## CHANGE ORDER

DATE:	January 19, 2011	CO #:	27 (TWENTY-SEVEN)
TO:	DAG Construction 4924 Winton Road Cincinnati, Ohlo 45232	PROJECT:	Gallatin County Lower Elementary Addition & Renovations Gallatin County, Kentucky BG 09-261 / RTA 0840
CONTRACT DATE:	April 16, 2010	CONTRACT FOR:	General Construction

PROPOSAL REQUEST

DATE:	October 1, 2010	PR #:	(14) Fourteen
TO:	DAG Construction 4924 Winton Road Cincinnati, Ohio 45232	RE:	Gallalin County Lower Elementary Addition & Renovations Gallatin County, Kentucky BG 09-261 RTA 0840

PR14-drawing

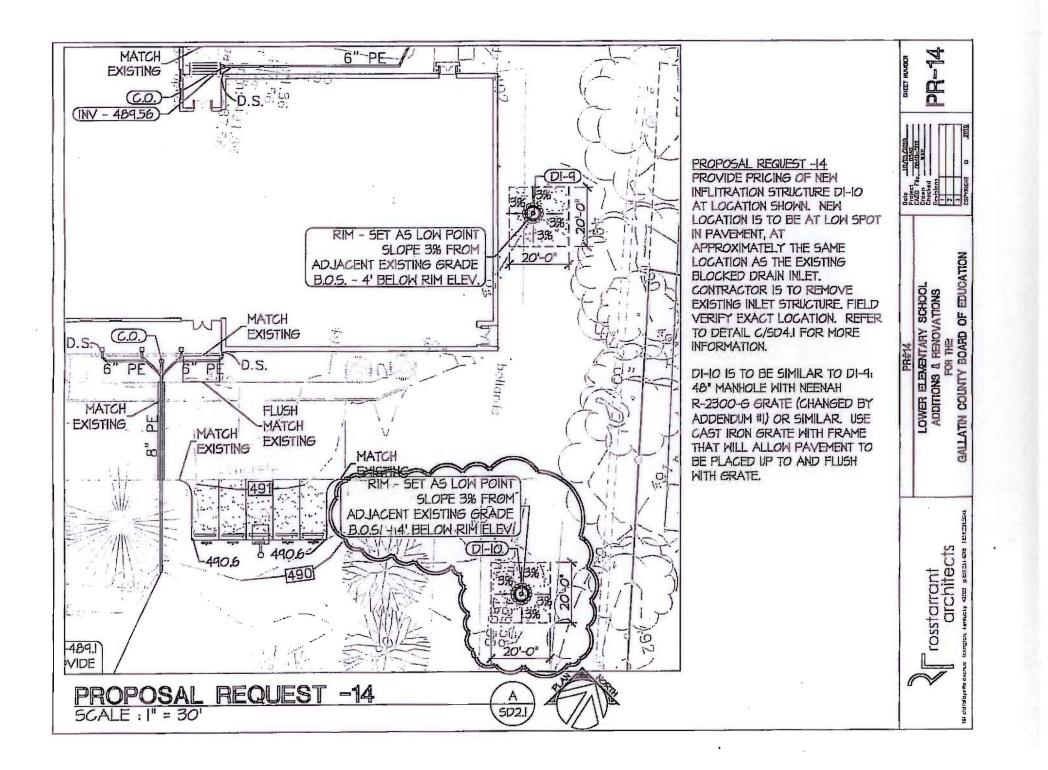
Refer to drawings SD1.0, SD1.1, SD1.2, SD2.1, SD2.2:

Provide pricing for removal of existing blocked storm inlet structure in school driveway, and installation of new infiltration structure DI-10, as indicated an attached drawing. DI-10 is to be similar to DI-9. Include asphalt repair at the area of installation in the pricing.
